PRODUCT SUPPORT BULLETIN # 427

SUBJECT: armatures with heavy brown / cream color slurry coating are suspect

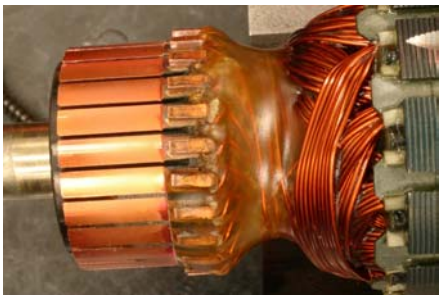
Due to early failure issue ***(less than 10%)*** **please inspect inventory of the following service replacement armatures** for the slurry coating at the commutator, see pictures below. Armatures with **heavy brown / cream color** slurry coating are suspect and should be removed from inventory and scrapped. An *authorized service station* should process a 'defective part from stock' claim for a full reimbursement of the armature's purchase price.

-Good thin slurry coat - top of wire [windings] are exposed... you should be able to feel the wire through the slurry with your finger for it to be considered 'thin' and 'good'. If there is a question on the thickness of the slurry coat, error on the side of caution and remove the armature from inventory.

-Questionable... heavy brown /cream slurry coating is suspect and should be removed from inventory.

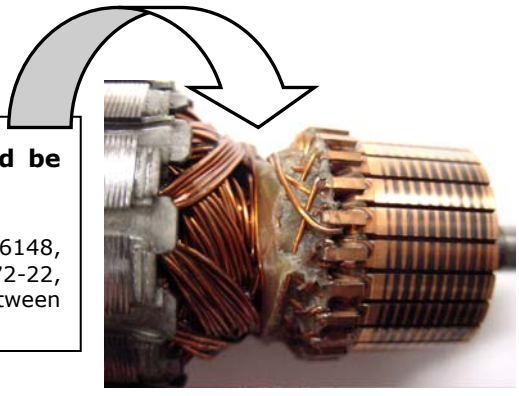
An armature that has slurry which has 'let-go' is defective and should be replaced under warranty.
